Planning Division MEMORANDUM

To:	Planning and Zoning Board
Through:	Nana Appiah, Planning Director
From:	Cassidy Welch, Planner II
Date:	October 13, 2021
Subject:	ZON20-00840 – Westmount Estates

Exhibit 1: Photo looking West from approximate driveway location

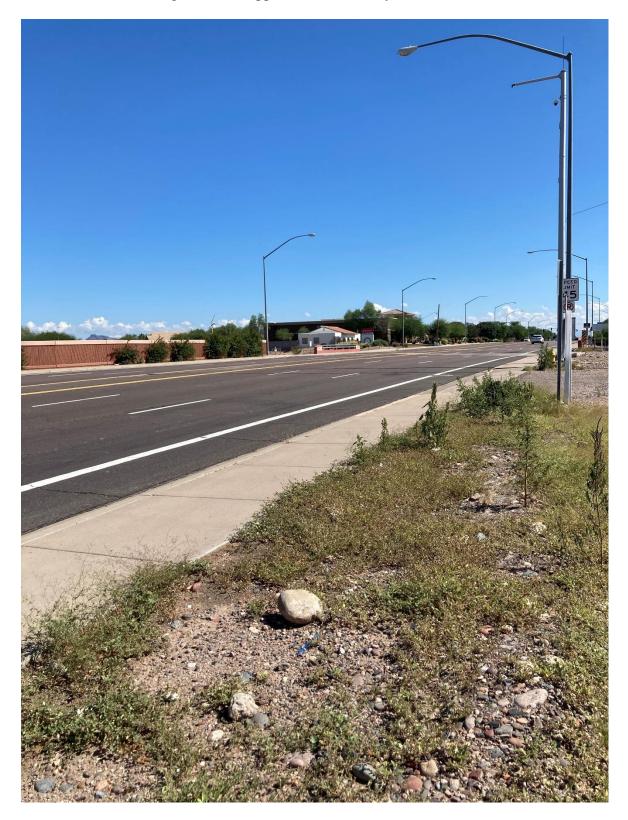
With removal of shrub, vehicles will have clear visibility to Horne, approximately ¹/₄ mile to the west of the subject site.
